Final SURFv6C design

Checklist

Freewheel diode (high current draw, no fan)

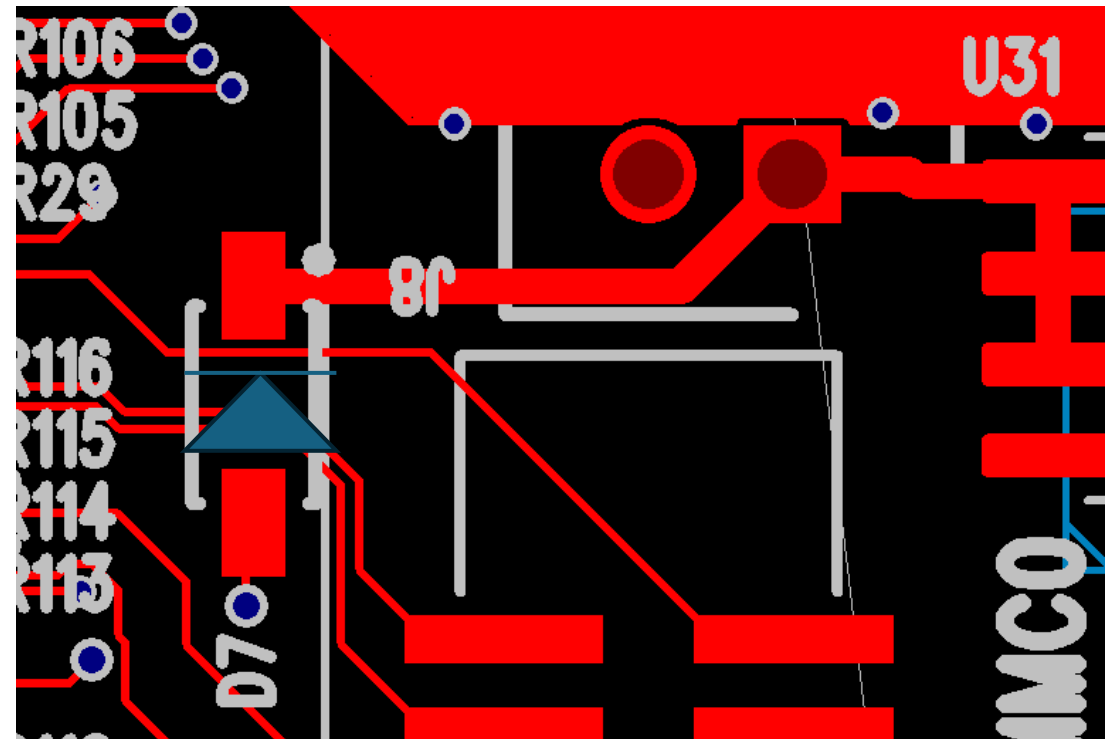
RevB (diode points to ground)

(ECO was just to flip the diode around)

RevC (diode points to power)

VCAP decoupling cap (unstable swap operation)

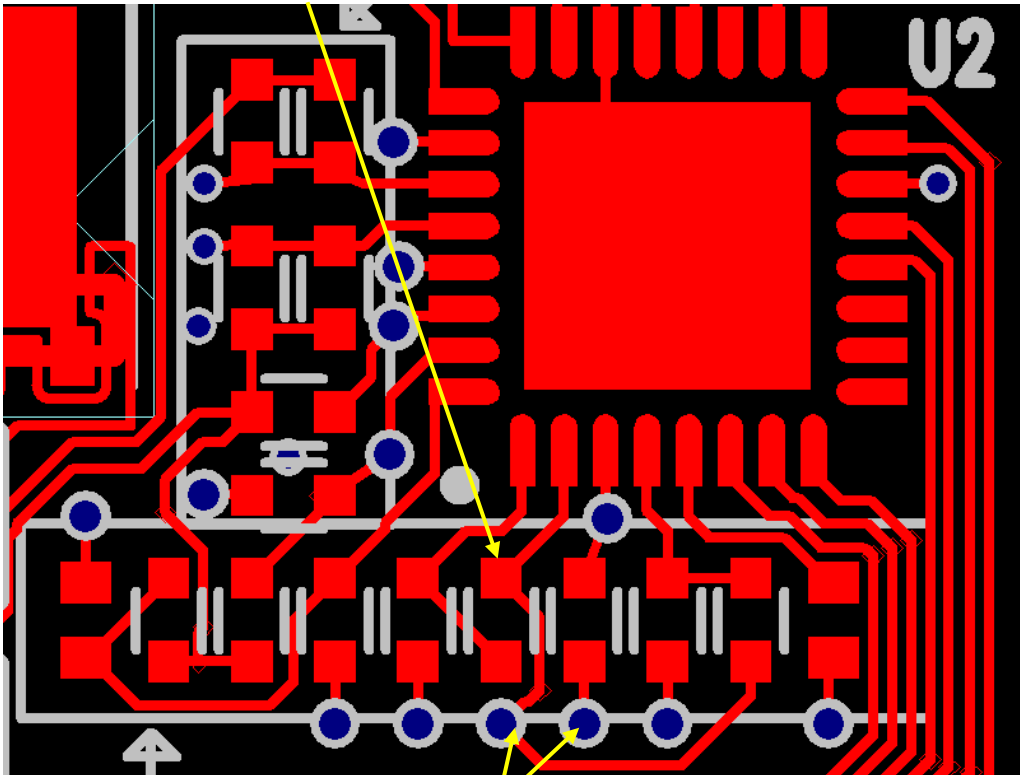
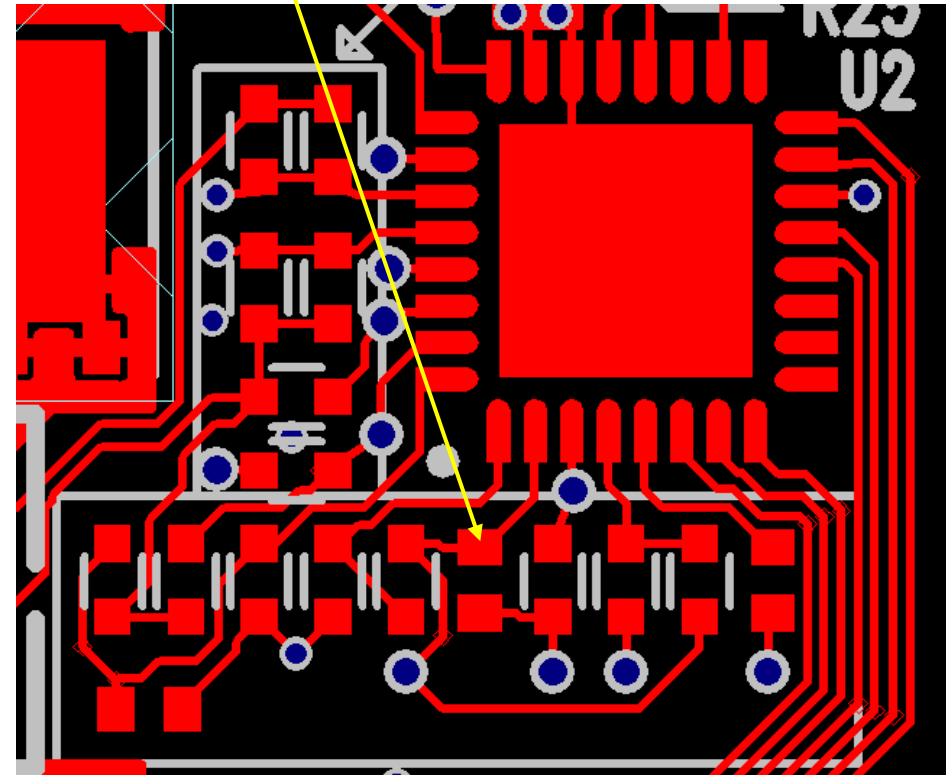
RevB: No VCAP decoupling

(ECO just added a cap between these vias)

RevC: VCAP decoupling

TXU0202 pinout (debug UART broken, pins swapped)

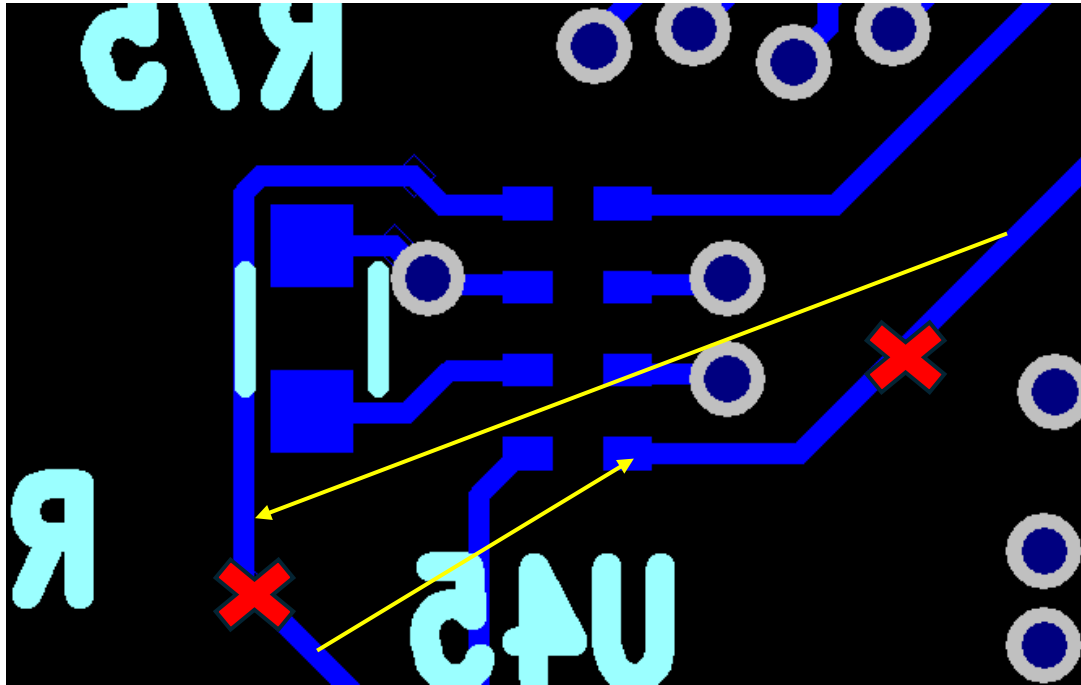
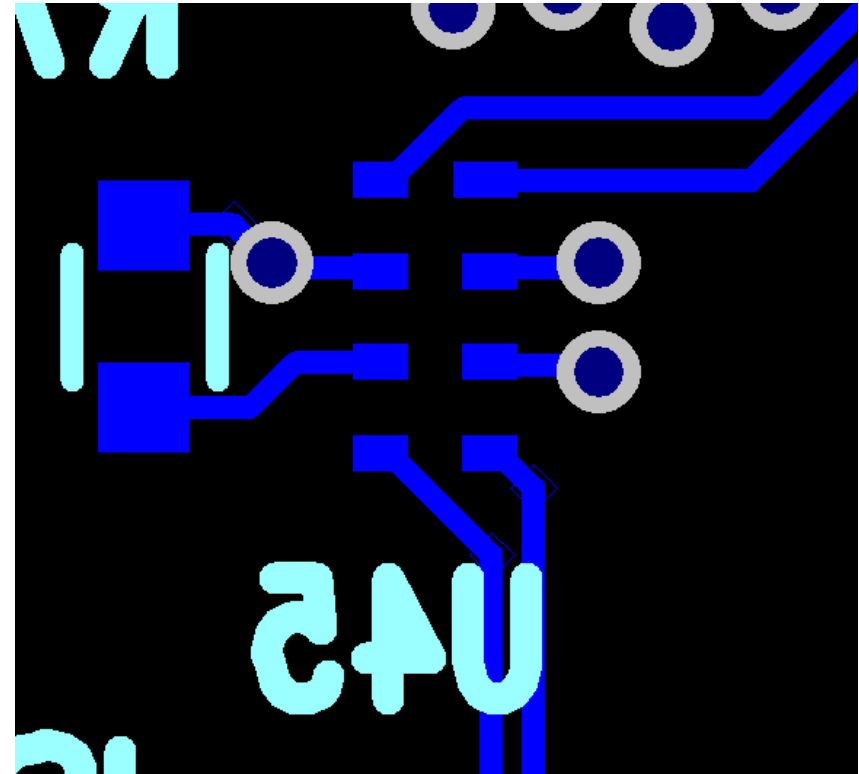
RevB: signals connected “L/R”

ECO is to cut and jumper

RevC: signals connected “T/B”

Remove 1.8V supervisor and pull up
(LMK reset held low, wrong part, correct part doesn't exist)

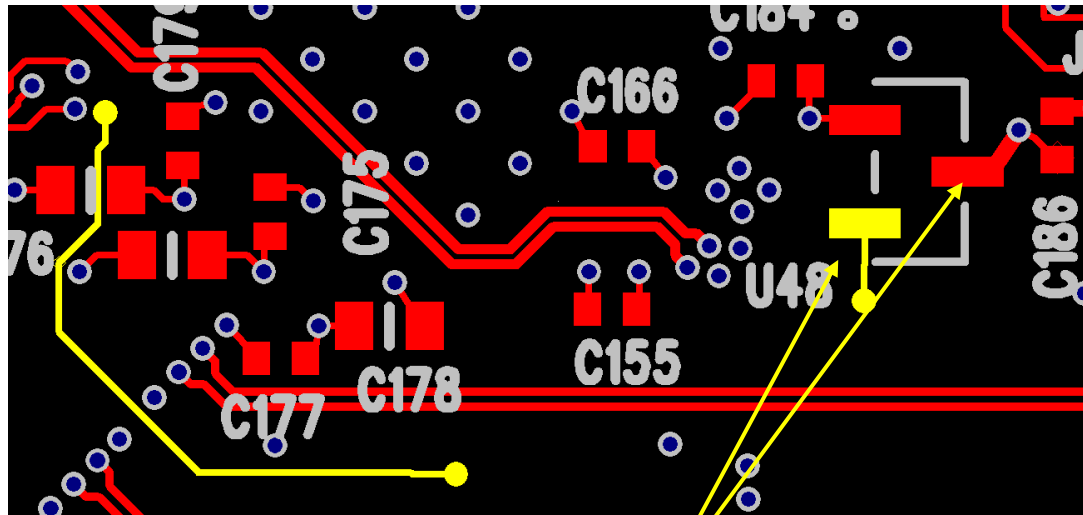
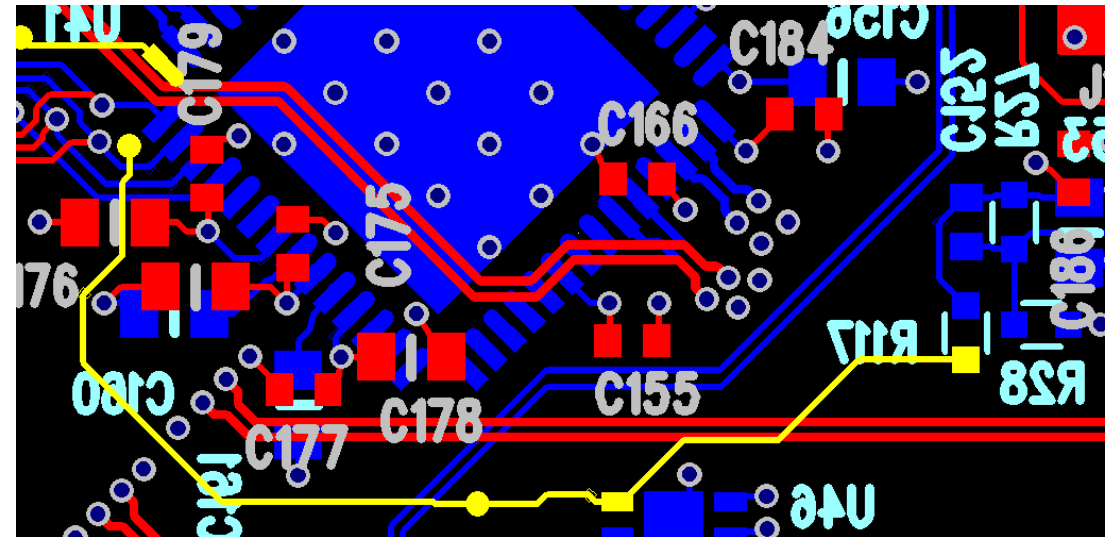
RevB: nonfunctional supervisor

RevC: only pullup

ECO is to just remove U48 and stick resistor across pads

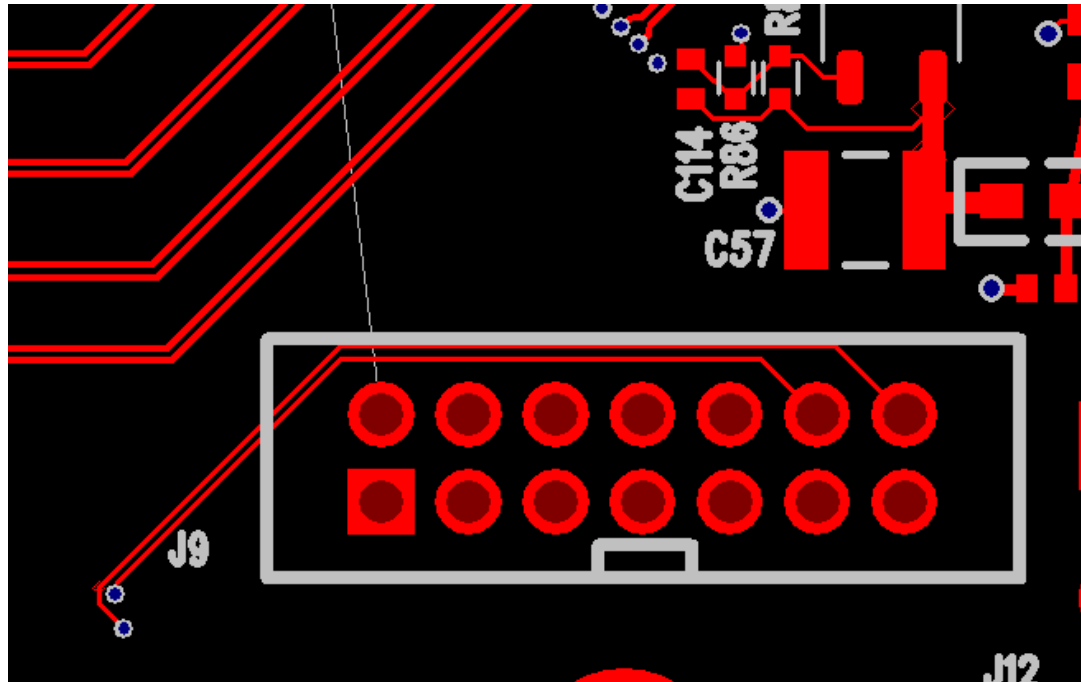
(with 3.3VSB off, TE0835 is driving into unpowered CPLD, maybe vice versa too)

DIR LOW is B->A
If VCCB is unpowered, I/Os are HiZ

locate caps near driver

ECO for revB is probably cut-and-jumper using a patch board or something

Add DT1446 diodes to JTAG (ESD), drop RX/TX
Also added use warning. Not a risk to TE0835, only to buffer
RX/TX unneeded and risky anyway (direct MIO connection to TE0835)

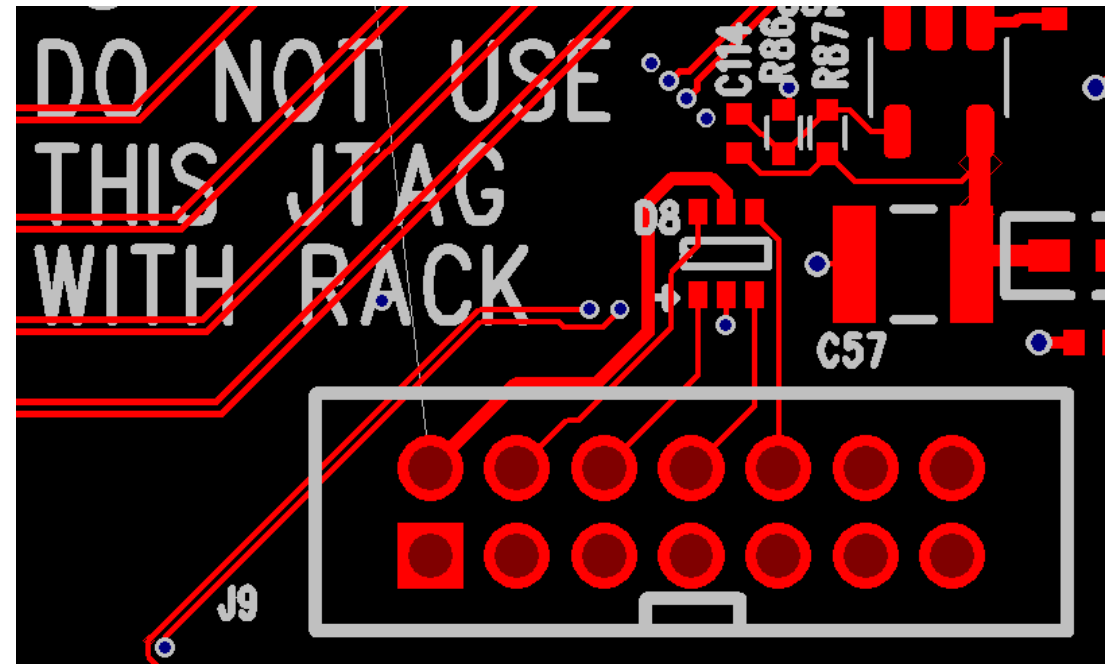
RevB: no ESD protection, RX/TX

RevC: ESD diode+warning, no RX/TX

ECO adds label (+ESD diodes on patch board)

AC coupling caps for MGTCLK

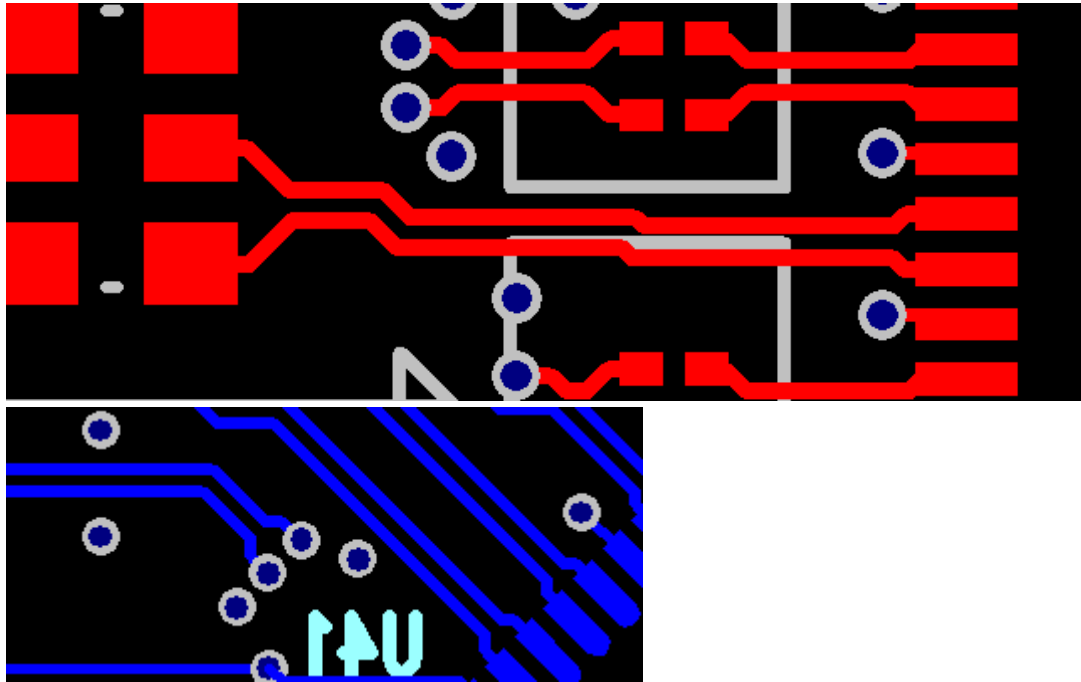
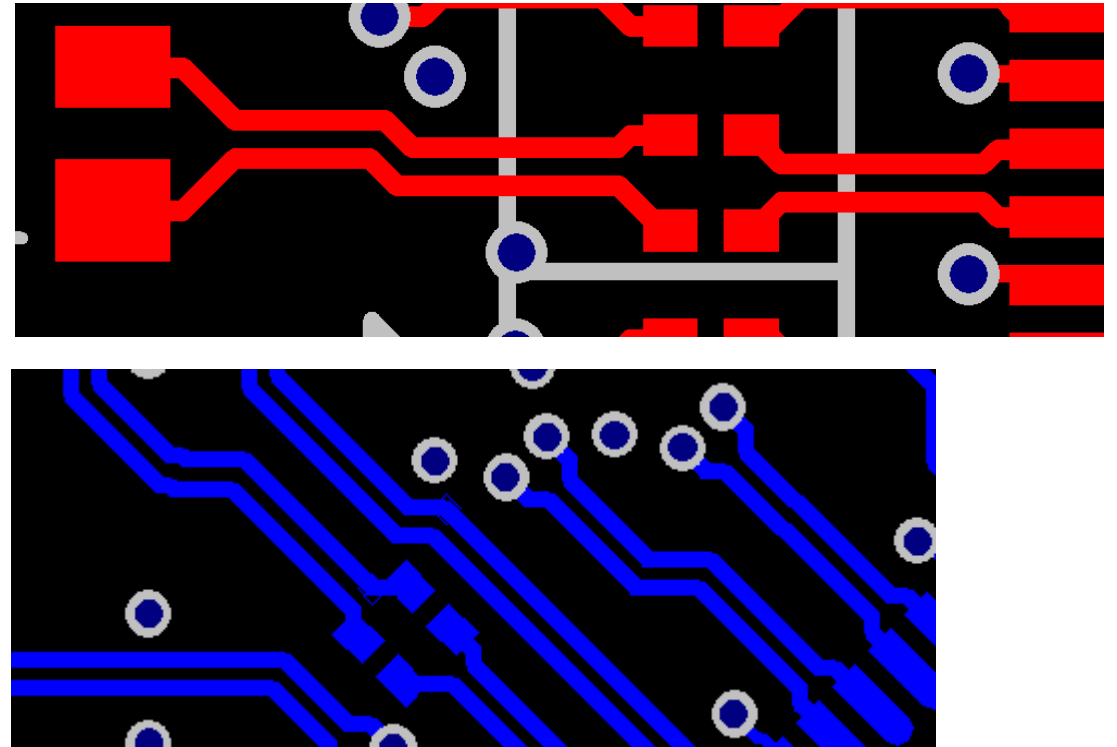
(no apparent problems but bad practice)

RevB: direct connections

RevC: AC coupling caps

ECO is cut traces and insert either near vias or pads

MGT onboard clock switch

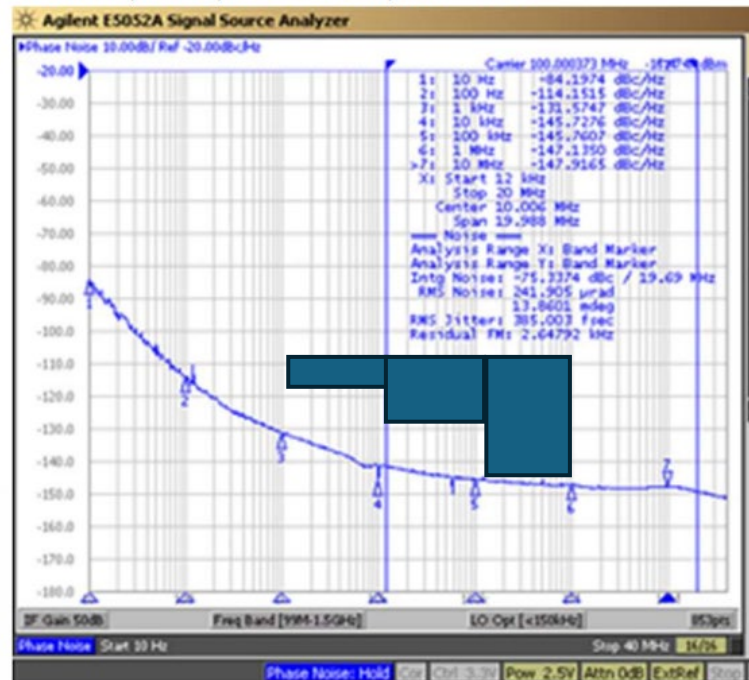
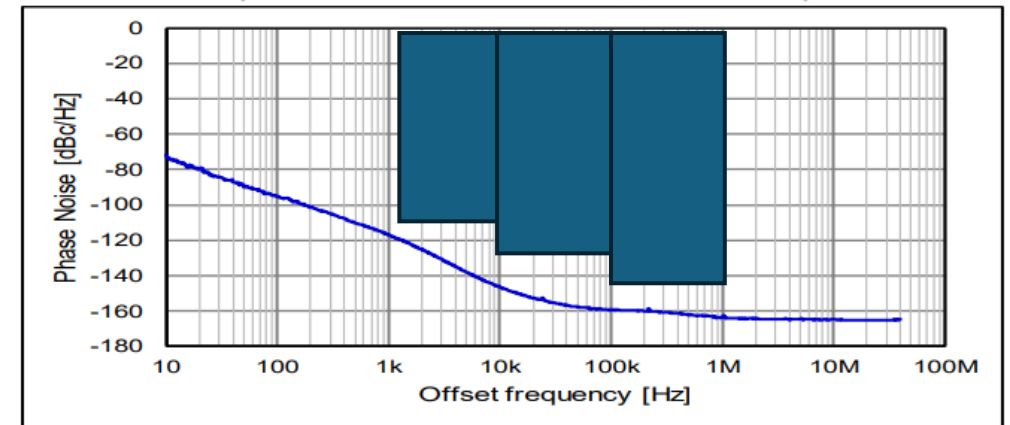
(only schematic/layout change is 3.3VCPLD->1.8V_CLK)

Reduce load on 3.3V_CPLD, phase noise only slightly increases

Option to switch back to 3.3VCPLD

n.b. this is 100M so *significantly* worse

3.3V/1.8V power option

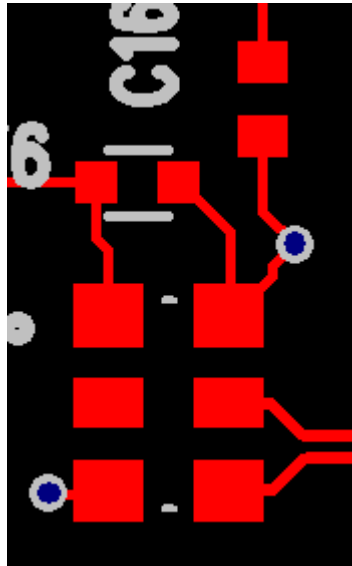
RevB: only 3.3V_CPLD

RevC: either 1.8V or 3.3V (1.8V nom)
